Category Vehicle Exterior

Section Exterior Panels/Trim Market USA

YEAR(S)	MODEL(S)	ADDITIONAL INFORMATION
2005 – 2010	tC	Plant Code(s): 0 WMI(s): JTK

Some 2005 – 2010 model year tC vehicles may exhibit a condition where the back door garnish becomes loose, and in some cases continued usage of the loose garnish may result in breakage. Please follow the procedure contained in this bulletin, which supplements the Repair Manual, to replace the back door garnish if it is loose or broken.

Figure 6.

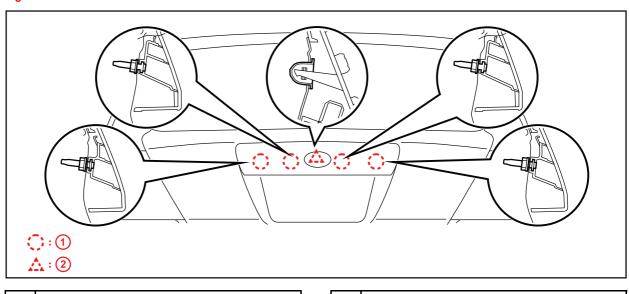
4. Remove the Back Door Outside Garnish Sub-assembly.

A. Remove the 4 nuts.

B. Detach the clip and disconnect the connector. Then remove the garnish.

- 6. Install the 2 screws and the opener switch in the NEW Back Door Garnish Sub-assembly (P/N 76801-21120-##).
- 7. Install the Back Door Outside Garnish Sub-assembly to the vehicle using the 4 nuts (P/N 90080-17189).

Torque: 4.9 N*m (49.9 kgf*cm, 43.5 in*lbf)
